## Economic Commission for Europe

#### 189th session

## Proposal for the 04 series of amendments to UN Regulation No. 117 (Tyre rolling resistance, rolling noise and wet grip)

### Submitted by the Working Party on Noise and Tyres\*

**"Annex 2 - Appendix 1**

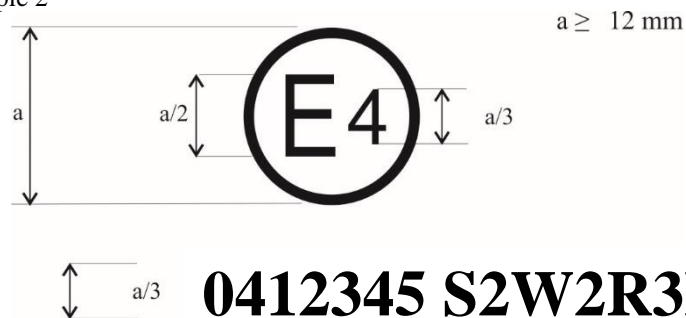
*Appendix 1,* amend to read:

The above approval mark, affixed to a pneumatic tyre shows that a tyre concerned has been approved in the Netherlands (E 4) pursuant to Regulation No. 117 (marked by S2 (rolling sound at stage 2) only), under approval number 0412345. The first two digits of the approval number (04) indicate that the approval was granted according to the requirements 04 series of amendments to this Regulation.

The above approval mark shows that the tyre concerned has been approved in the Netherlands (E 4) pursuant to Regulation No. 117 (marked by S2 (rolling sound at stage 2) W2 (wet adhesion of tyres in new state at stage 2), R3 (Rolling resistance at stage 3) and B (wet adhesion of tyres in worn state)) under approval number 0412345. The first two digits of the approval number (04) indicate that the approval was granted according to the requirements of the 04 series of amendments to this Regulation."

Example 1

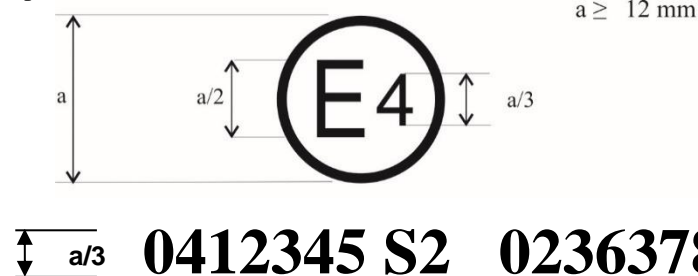
*Appendix 2*, amend to read:

The above approval mark shows that the tyre concerned has been approved in the Netherlands (E 4) pursuant to UN Regulation No. 117 (marked by "S2" (rolling sound at stage 2)), under approval number 0412345 and UN Regulation No. 30, under approval number 0236378. The first two digits of the approval number ("04" and "02") indicate that the approval was granted according to the 04 series of amendments and the approval pursuant to UN Regulation No. 30 according to the 02 series of amendments.

Example 2

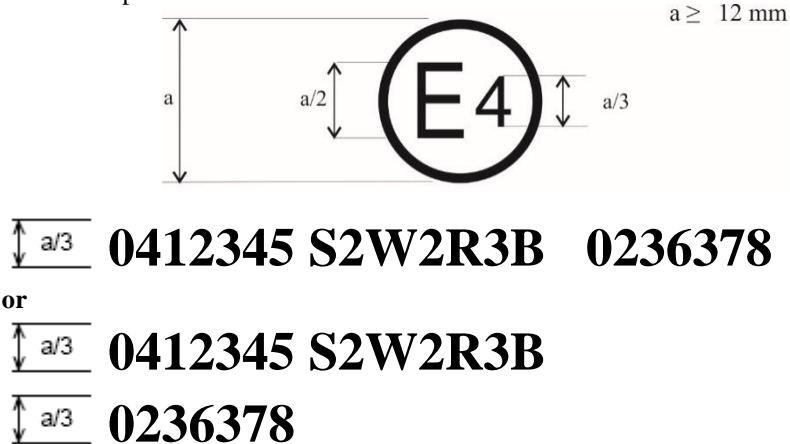
The above approval mark shows that the tyre concerned has been approved in the Netherlands (E 4) pursuant to Regulation No. 117 (marked by "S2W2R3B" (rolling sound emission at stage 2, wet adhesion of tyres in new state at stage 2, rolling resistance at stage 3 and wet adhesion of tyres in worn state)), under approval number 0312345 and UN Regulation No. 30 under approval number 0236378. The first two digits of the approval numbers ("04" and "02") indicate that the approval pursuant to UN Regulation No. 117 was granted according to the 04 series of amendments and the approval pursuant to UN Regulation No. 30 according to the 02 series of amendments."

Example 3

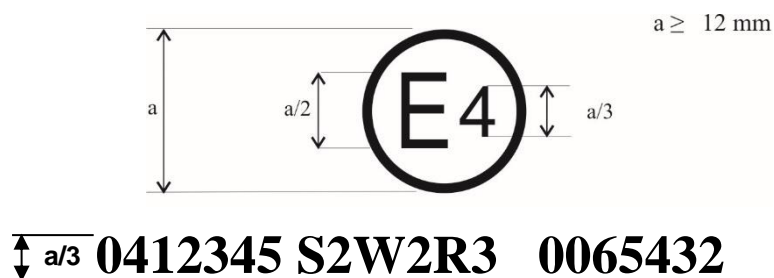
The above approval mark shows that the tyre concerned has been approved in the Netherlands (E4) pursuant to UN Regulation No. 117 (marked by "S2W2R3" (rolling sound emission at stage 2, wet adhesion of tyres in new state at stage 2 and rolling resistance at stage 3)), under approval number 0412345 and UN Regulation No. 54 under approval number 0065432. The first two digits of the approval numbers ("04" and "00") indicate that the approval pursuant to UN Regulation No. 117 was granted according to the 04 series of amendments and the approval pursuant to UN Regulation No. 54 according to its original form."

Example 1

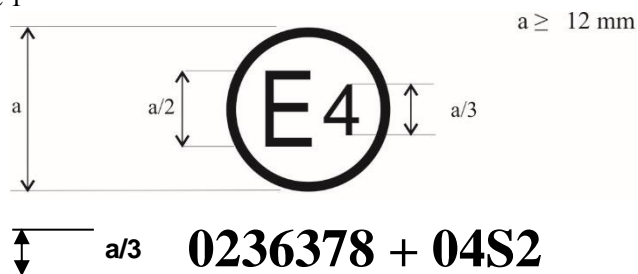
Appendix 3, amend to read:

The above approval mark shows that the tyre concerned has been approved in the Netherlands (E4) pursuant to UN Regulation No. 30 according to its 02 series of amendments (indicated by the first two digits of the approval number, "02") under approval number 0236378. It is also marked by "+ 04S2" which indicates that the tyre was also approved pursuant to UN Regulation No. 117 (04 series of amendments) for S (rolling sound emission at stage 2).

Example 2

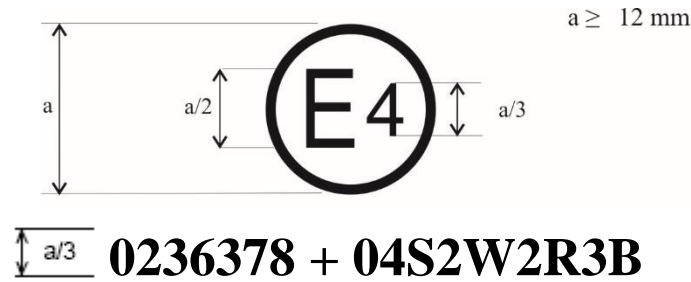
The above approval mark shows that the tyre concerned has been approved in the Netherlands (E4) pursuant to UN Regulation No. 30 according to its 02 series of amendments (indicated by the first two digits of the approval number, "02") under approval number 0236378. It is also marked by "+ 04S2W2R3B" which indicates that the tyre was also approved pursuant to UN Regulation No. 117 (04 series of amendments) for S (rolling sound emission at stage 2) W (wet adhesion of tyres in new state at stage 2), R (rolling resistance at stage 3) and B (wet adhesion of tyres in worn state)."

Example 1

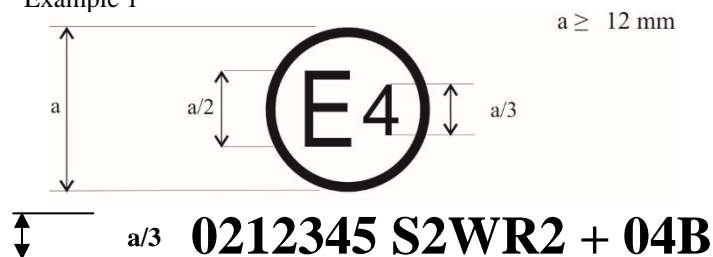
Appendix 4, amend to read:

The above approval mark shows that the tyre concerned has been initially approved in the Netherlands (E4) pursuant to UN Regulation No. 117 and the 02 series of amendments under approval number 0212345. The marking is complemented by S2WR2 (rolling sound emission at stage 2) W (wet adhesion of tyres in new state) and R (rolling resistance at stage 2). The "04B" preceded by "+" indicates that it has had its approval extended under UN Regulation No. 117 and 04 series of amendments to wet adhesion of tyres in worn state based on separate certificate."
